FLUE GAS DESULPHURISATION (FGD) SYSTEM PACKAGE FOR
RGTPP, HISAR (2X600 MW)

Section VIII
(Amendments & Clarifications, Part-I)

FLUE GAS DESULPHURISATION (FGD) SYSTEM PACKAGE FOR
 RGTPP, HISAR (2X600 MW)
 AMENDMENT NO. **5/CE/PLG/NTPC/RGTPP/FGD-250- Amdt-01**

FLUE GAS DESULPHURISATION (FGD) SYSTEM PACKAGE FOR
 RGTPP, HISAR (2X600 MW)
 CLARIFICATION NO. **5/CE/PLG/NTPC/RGTPP/FGD-250- Clrf.-01**

2 X 600 MW Hissar Thermal Power Project at BARWALA, Hissar
(Haryana)

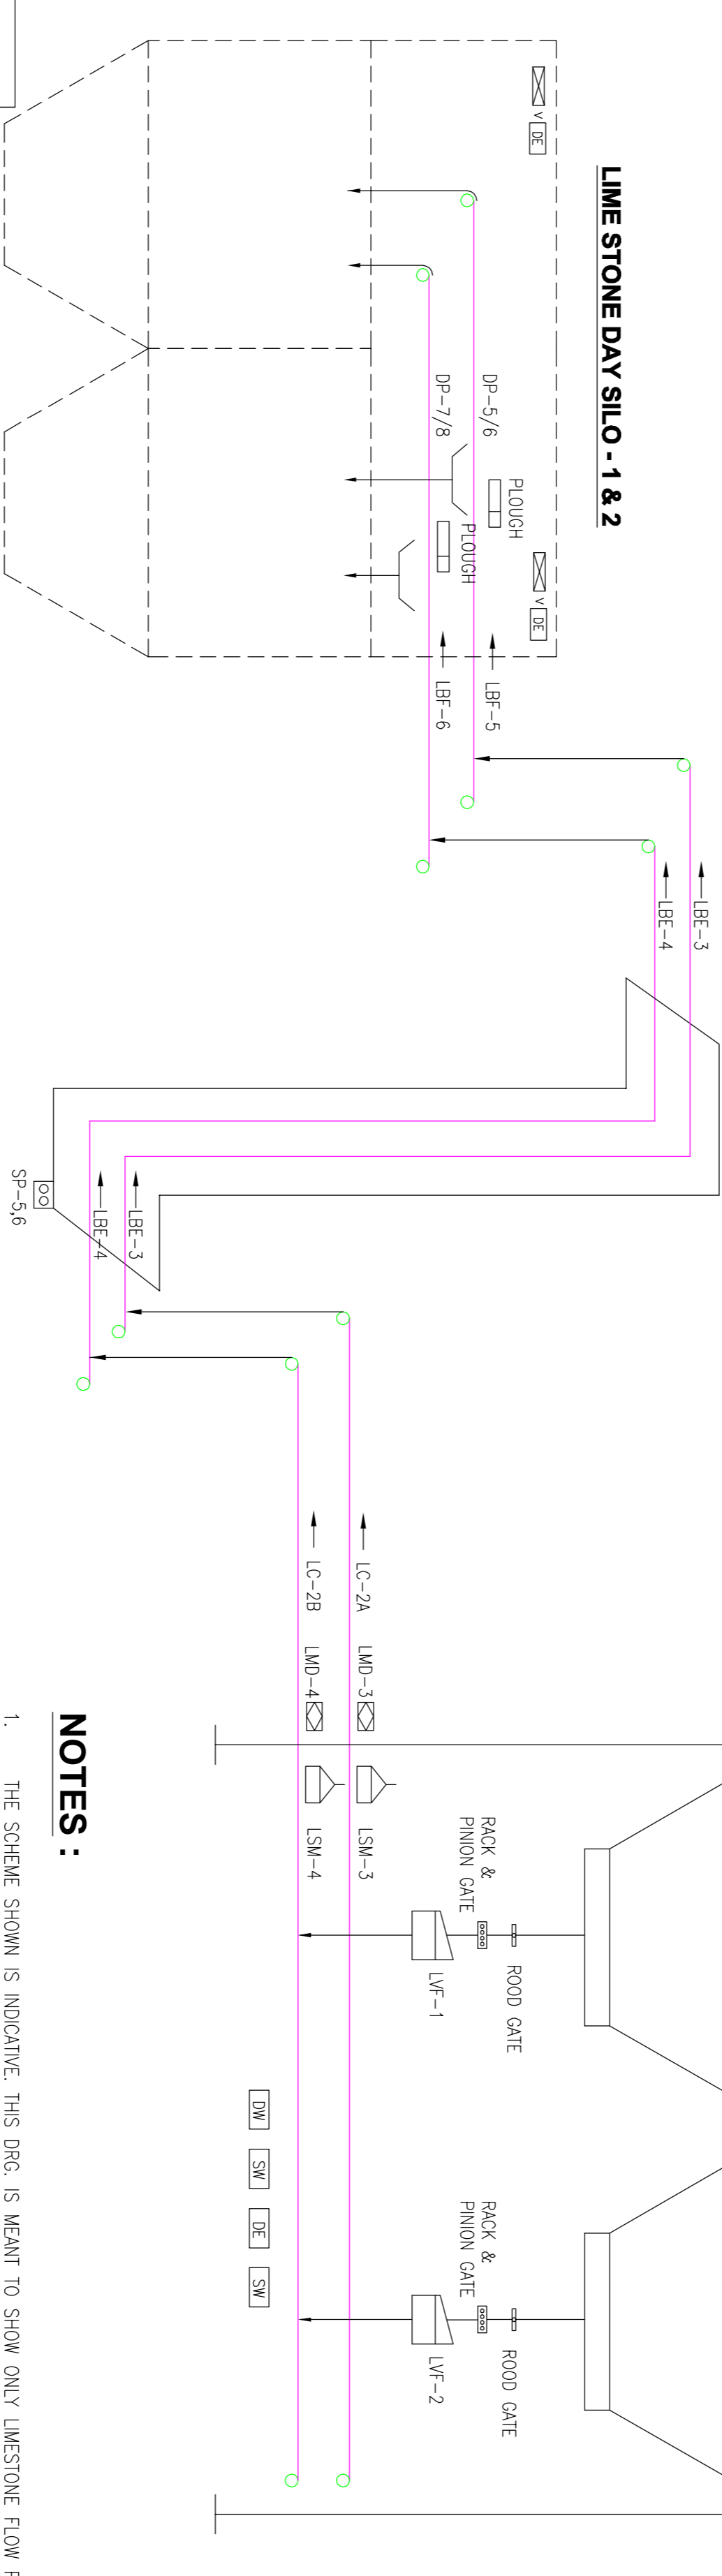
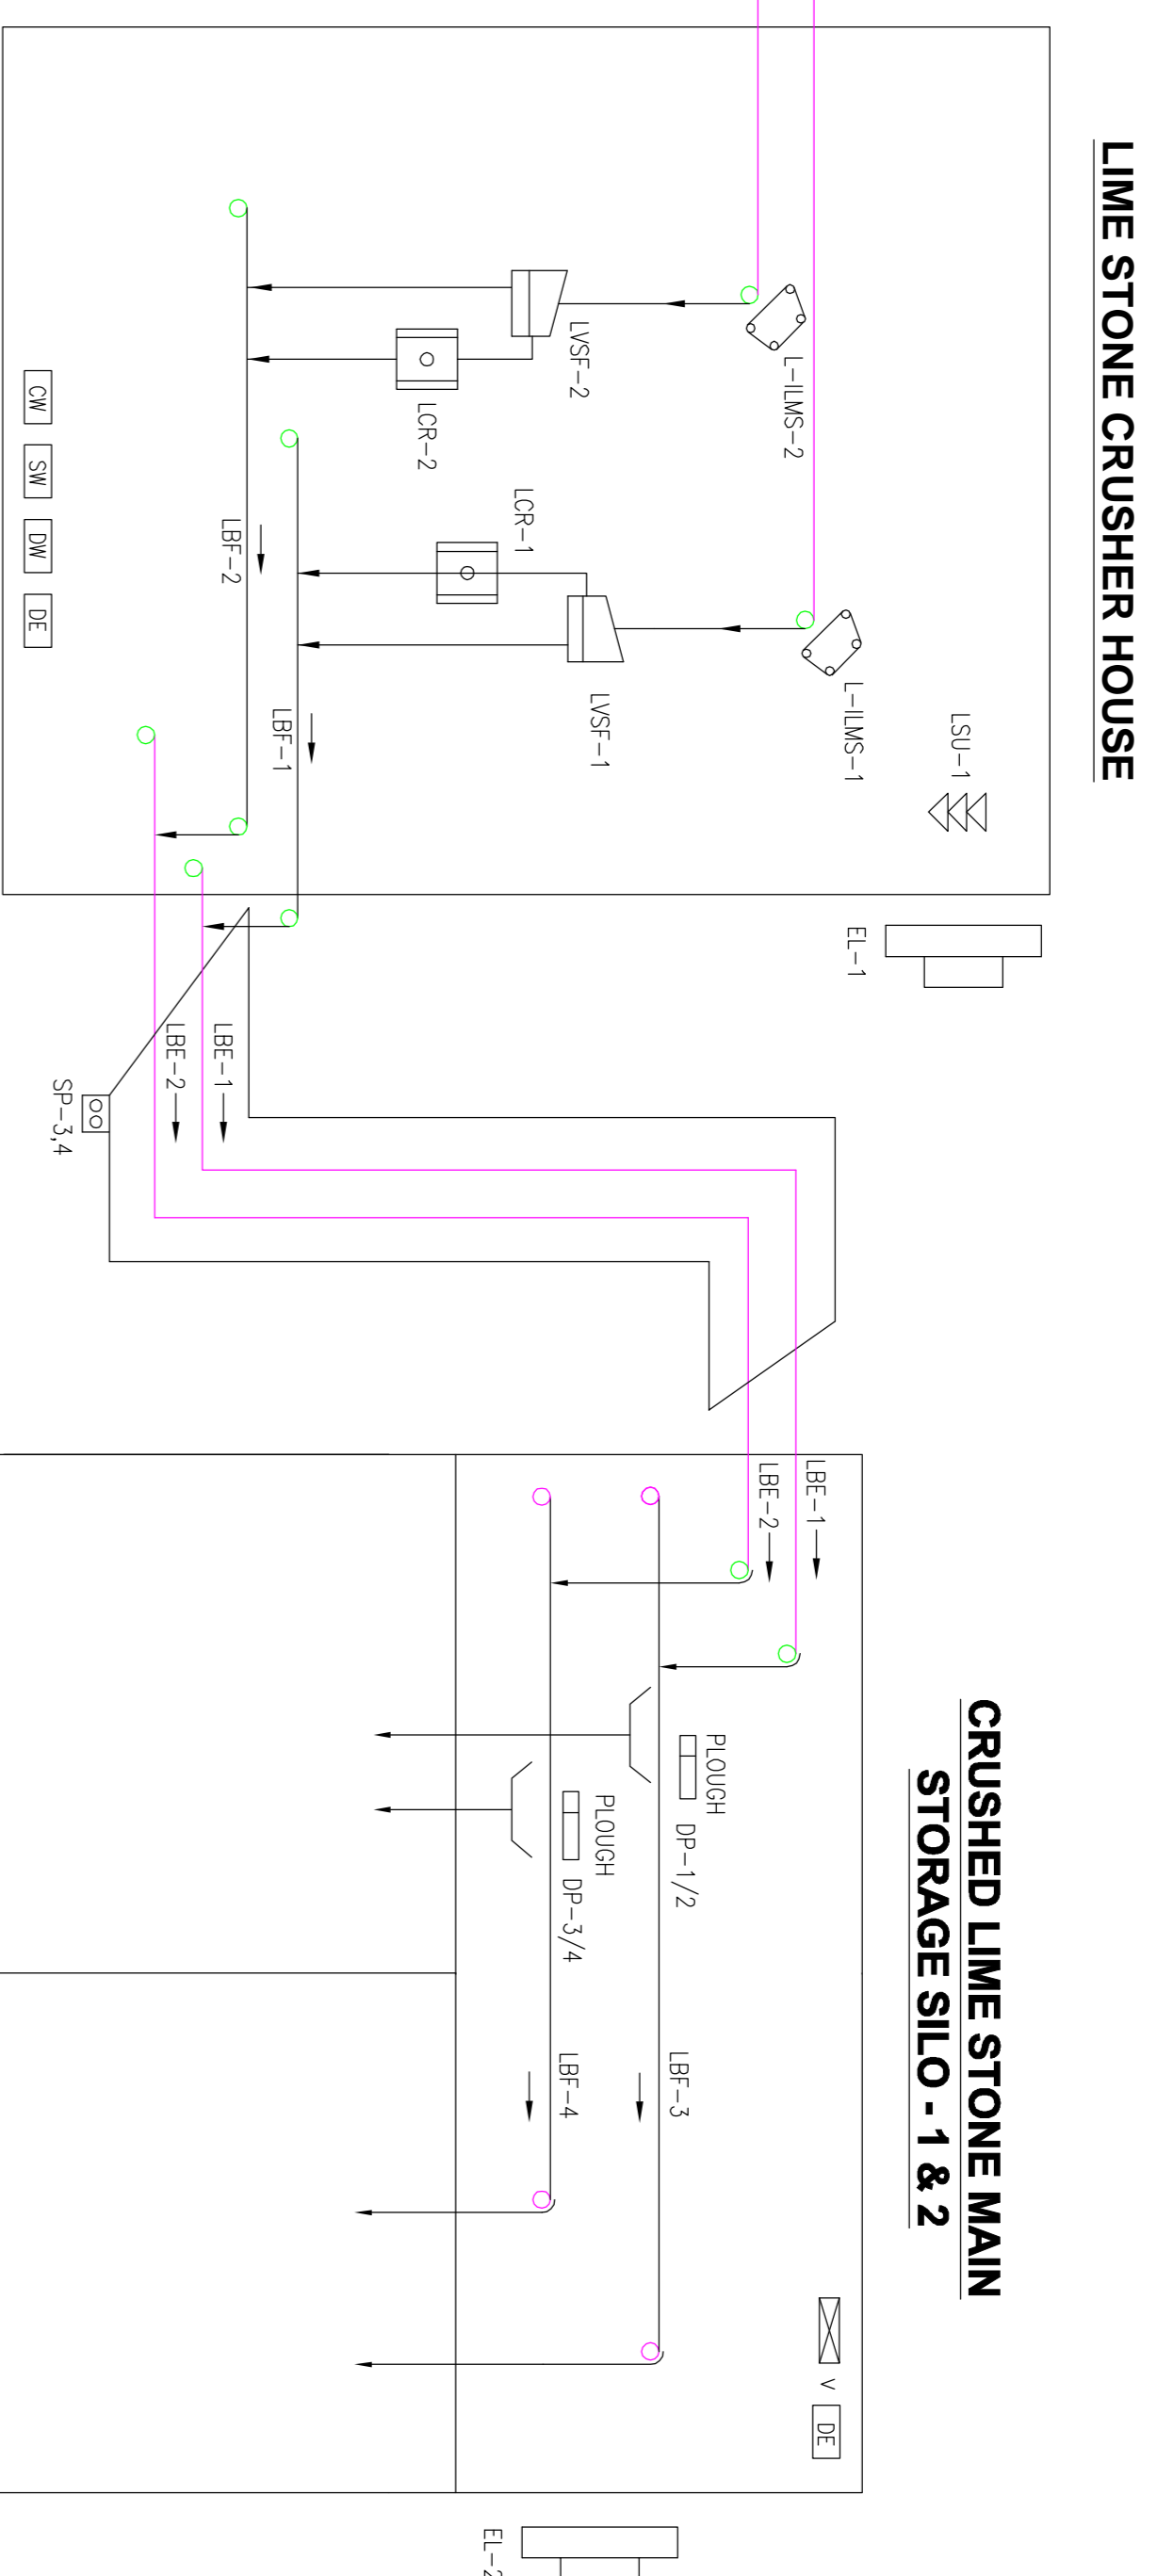
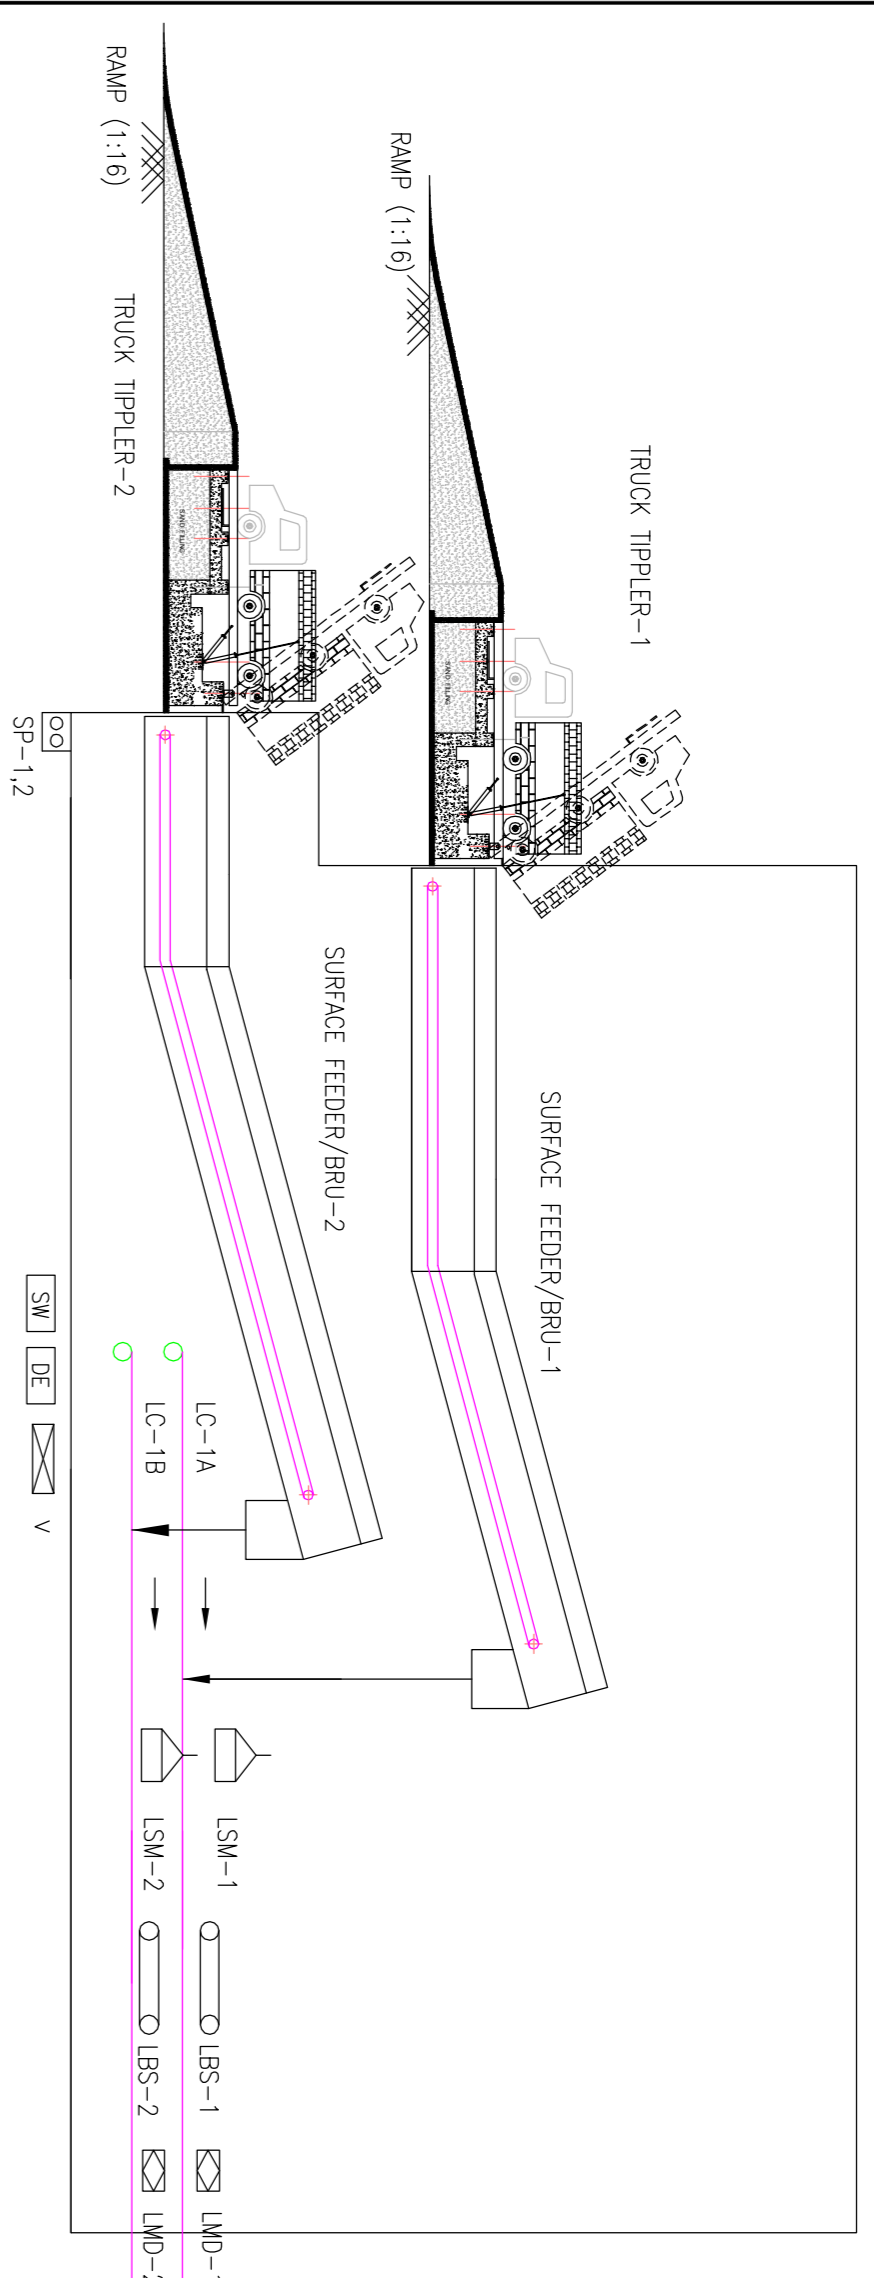
15.	VI/E				Drawing no 9944-250-POM-A-005 Rev. 0	Drawing no 9944-250-POM-A-005 Rev. A	typographical error

190	VI/A	III-A5	4 OF 7	2.01.16	Two (2) numbers of Conventional enclosure type passenger cum goods elevator Drawing no 9944-250-POM-A-005	The referred specification & Flow digram for number of elevator is Contradictory . Bidder will follow as per flow diagram (1 No elevator) for limestone crusher house	Bidder to provide Two (2) numbers of conventional enclosure type passenger cum goods elevator to serve vari-ous floors of limestone crusher house and Crushed Limestone Main storage Silo Bidder to refer Amendment in this regard.
